## DESIGN ADJUSTMENTS

Per HPC Meeting on 3/12/19

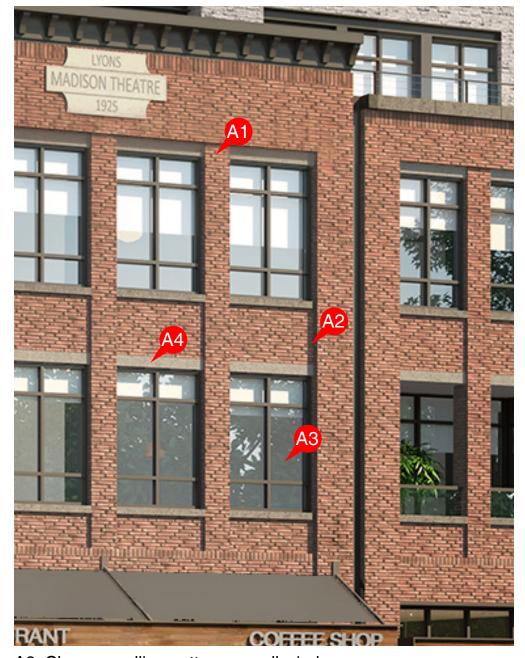
A2. Reduce the depth of recess in window openings.

A3. Change mullion patterns on all windows.

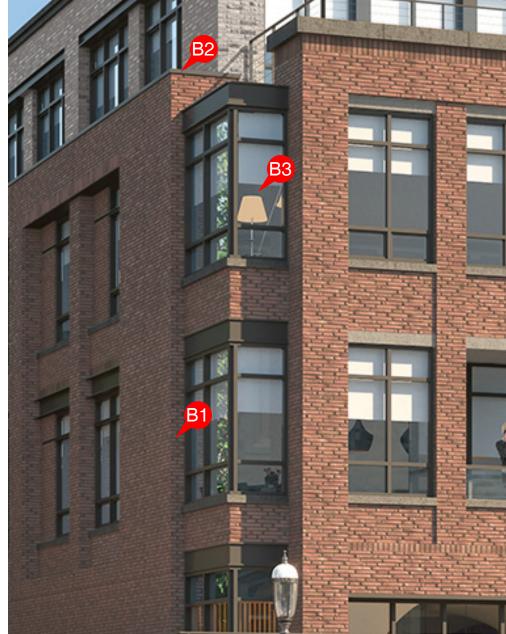
A4. Replace metal lintels with limestone.

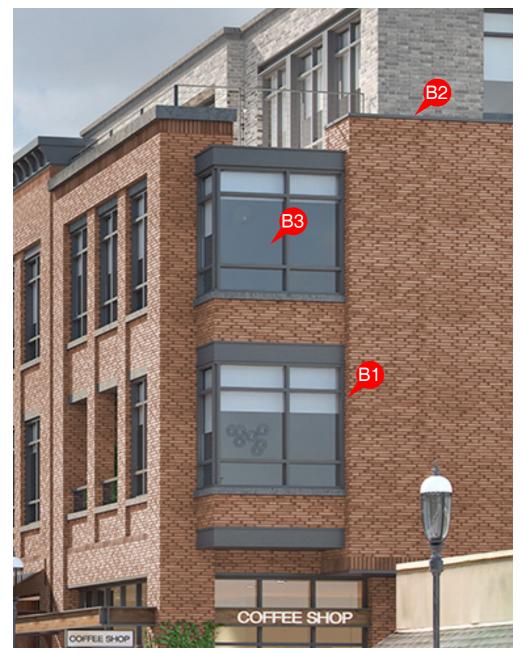
- B1. Reduce the size of bay windows.
- B2. Raise parapet along the third floor.
- B3. Change mullion patterns on bay windows.

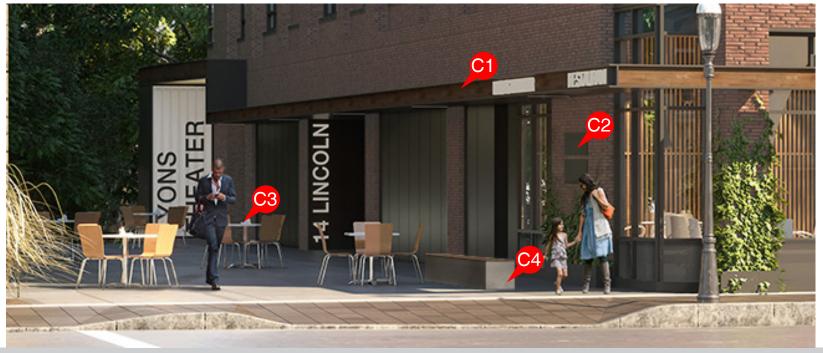
- C1. Middle canopy has been made higher with fabric awning. Add wood infill on the front face of canopy.
- C2. Retail doors have been relocated to the center, and have been recessed back 2 feet.
- C3. Revise the lower part of the storefront to metal spandrel panels.
- C4. Add planters to grow ivy on ground floor.

- C1. Add wood infill on the front face of canopy along the west side.
- C2. Add plaques to exhibit the history of Madison Lyons Theater.
- C3. Add outdoor seating / planters to vitalize the open space.
- C4. Add benching along walkway to theater entrance.
